Sundry Print Report

Well Name: BOB BREWER COM

Notice of Intent

Type of Action: Plug and Abandonment

Proposed Wellbore P&A Diagram

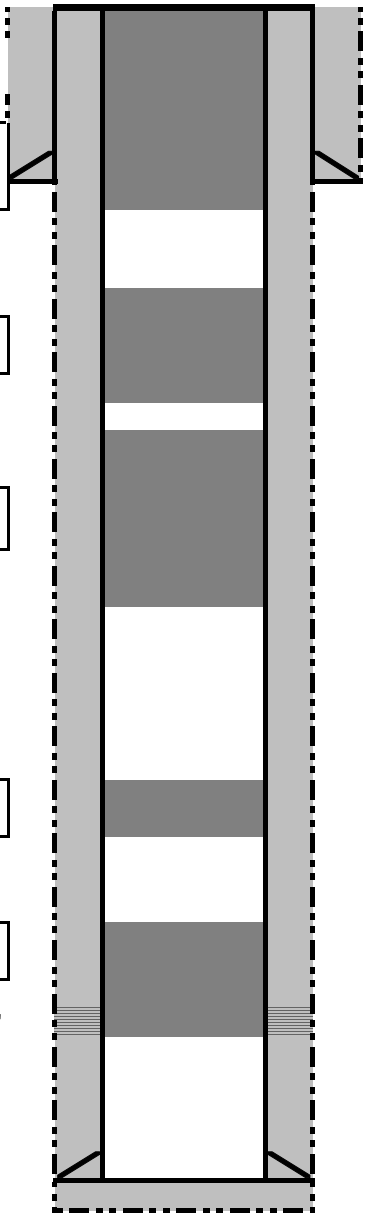
- BLM pick for the Ojo Alamo formation top varies from Operator. Plug proposed in the P&A procedure is sufficient to cover BLM pick.
- No CBL on file.
- The plugs proposed in the P&A procedure will adequately protect any freshwater sands in this well bore.
- Gallup perfs 4738’ – 4812’.

You are also required to place cement excesses per 4.2 and 4.4 of the attached General Requirements.
